INDESIT company

MB4031NFIT

F029466

n1030059: Modification of freezer doors on Ariston Opera-60 combined fridge-freezers (cond

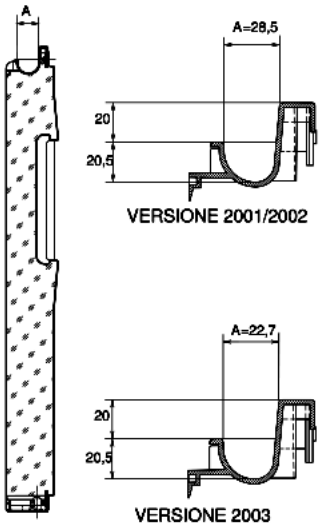
In March 2003 the Melano factory started using freezer doors with modified handle on the Ariston Opera-60 combined fridge-freezers (models MB-MBA-MBAA), in order to eliminate the problem of condensation.
The grip width has been reduced (from 28.5 to 22.7 mm) on these doors, as indicated by the dimension (A) in the figure (N1030059FIG1).
These freezer doors are already available as replacements and a coloured label on the packing distinguishes them from the previous ones. This will be done until stocks of premodification doors run out.
The codes of the freezer doors have not been changed:

Models (MBAA3811)
C00089881 - FREEZER DOOR-ROUNDED /NEW WHITE 592x713x81

Models (MBA3332-MBA3832-MBA3842-MBA4042 / MB3822-MB4022)
C00081999 - FREEZER DOOR- ROUNDED/NEW S/STEEL 592x713x81

Models (MBA3833- MBA4033)
C00083757 - FREEZER DOOR- ROUNDED/NEW SILVER 592x713x81

Models (MBA3835- MB4035)
C00084420 - FREEZER DOOR- ROUNDED/NEW 1003-YELLOW 592x713x81

Models (MBA3835- MBA4035)

C00084430 - FREEZER DOOR- ROUNDED/NEW BLUE 592x713x81 (MBA3835-4035)

Models (MBA3311-MBA3331-MBA3811-MBA3821-MBA3831-MBA3818-MBA3841) (MBA3841-MBA4021-MBA4031-MBA4041) (MB3321-MB3811-MB3821)

C00081997 - FREEZER DOOR- ROUNDED/NEW WHITE 592x713x81

In April / May 2003, production standardised the use of the inner door on all these doors, increasing the insulation efficiency by approx. 3%.
The door C00089881 offers approx. 10% more insulation than the door C00081997.

n1030067: Noisy freezer compartment fan in Ariston and Indesit Opera-60 total no-frost fri

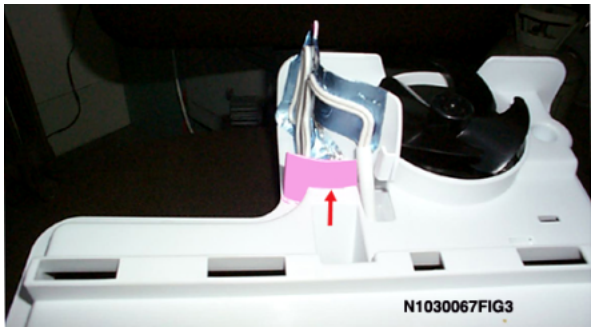
On Ariston and Indesit Opera60 Total No Frost fridge-freezers produced before August 2003, the freezer fan may stop due to ice build-up (stalactites), activating the alarm.
The problem has been solved by emptying the conveyor (chamber separator) in the upper part to give the fan more space (see fig.1).

To solve the problem in products in use, an air conveyor kit (Sat code 094490), which also includes modifications to reduce dispersion air flow, has been introduced since 25/9/2003 (see fig.2) and 06/10/2003 (see fig.3).

n1030068: Low fridge compartment temperatures in Ariston and Indesit Opera-60 Total No Fro

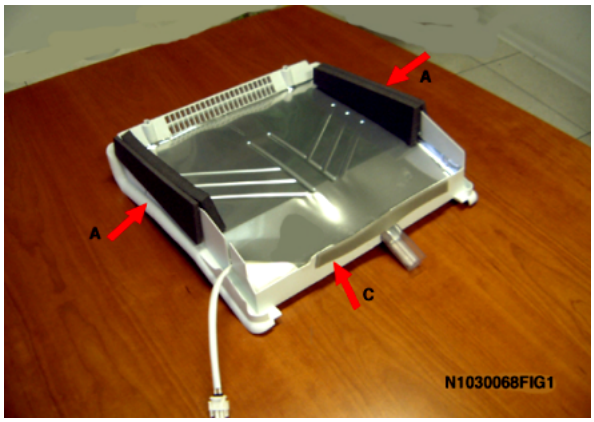
In Ariston and Indesit Opera-60 Total No Frost fridge-freezers produced before June 2003, there may be a lowering of the fridge compartment temperature in the crisper area (with freezing of food) due to the backflow of cold air from the freezer.
This problem generally occurs when the "super freezer 24 or 48 hours" function is set.
The problem has been solved as follows:

1) The "Super freezer-24 hours" power card software has been modified. The power cards managed as spare parts (095711 - 094383) were all replaced on 01/06/2003.

2) The lower vents on the multiflow have been closed from the inside (see fig.3/4-ref.A) and the outlet of those located in the curved area has been reduced (see fig3/4- ref.B). To solve the problem on products in use there are two spare part kits: 094675 for the version with three outlets, and 094737 for that with four.

3) The two side sponges on the freezer separator have been lengthened (see fig1-ref. A) and another has been fitted at the back, in the outlet hole area (see fig.1-ref C). Kit 097661 is managed to solve the problem on products in use. This kit includes a double filament resistance (see note N1030069).

4) The air conveyor has been modified to improve air circulation (see N1030067 fig. 2-3). Kit 094490 is managed as a spare part to solve the problem on products in use

n1030069: Freezer compartment drip hole obstructed on Opera60 Total No Frost fridge-freeze

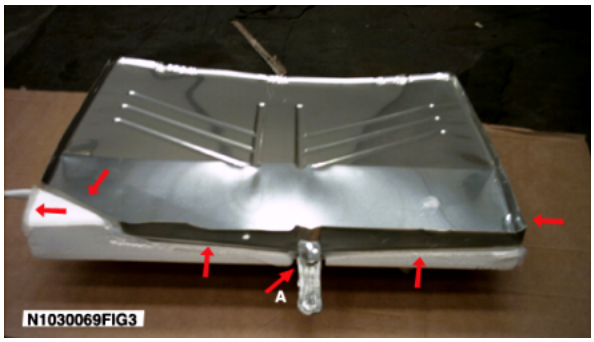
On Ariston and Indesit Opera60 Total No Frost fridge- freezers produced before June 2003, the freezer separator drip hole may be obstructed due to ice build-up.

The problem has been solved by fitting a double filament resistance at the end part, which can be seen by removing the rubber protection. (see fig. 1). The resistance is glued to the drip (see fig. 2).
Freezer separator Sat code 094485, complete with modified resistance, is managed as a replacement to solve the problem on products in use.

If the 40W resistance needs replacing it will be necessary to restore the sealing, located in the hole area, using silicone (see fig3 - ref A).
Also, to protect the separator from possible water penetration, silicone is used to protect the drip with polystyrene insulation at the back, and also the right corner, relevant to the wiring outlet is protected with silicone in the upper part.

N1030079FIG2

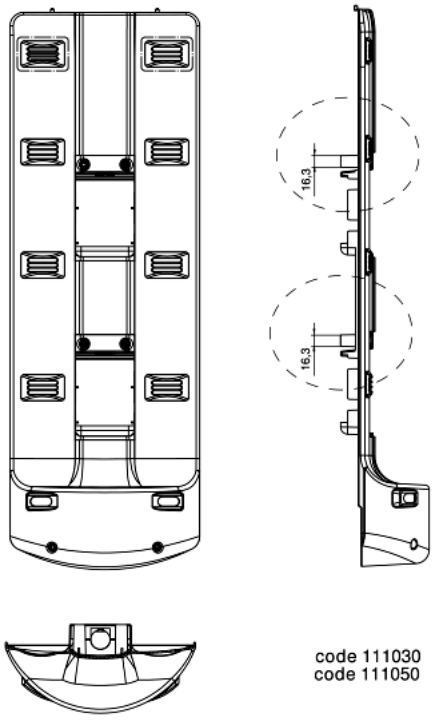
In June 2004 (serial no. 40604.0001), the Melano factory modified the multiflow fixing system to the shell on Ariston and Indesit Opera-60 Total No Frost fridge-freezers.
The inner wall of premodification models featured four square marks (20x20) in the central area for fixing the multiflow cover. The four marks have been eliminated and the wall only features the position for the holes.
Furthermore, the head of the four pins that house the fixing screws on the multiflow cover have been modified. Premodification items ended with an external diameter of 9 mm, whereas the current version has a diameter of 16.3 mm (see figures N1030079FIG1 and FIG2).
The new multiflow cover can be mounted on premodification models but not vice versa, paying attention not to overtighten the screws as the pins may break. If necessary, bush 039567 can be used as stopper.
The multiflow cover is managed as Kit to solve the problem, on products in use, of the formation of condensation on the vegetable basket due to the inflow of cold air from the freezer (see note N1030068).

111030 - 4-way multiflow cover KIT (serial no. 40604.0001)

111050 - 3-way multiflow cover KIT (serial no. 40717.0001).

094737 - 4-way multiflow cover KIT
094675 - 3-way multiflow cover KIT
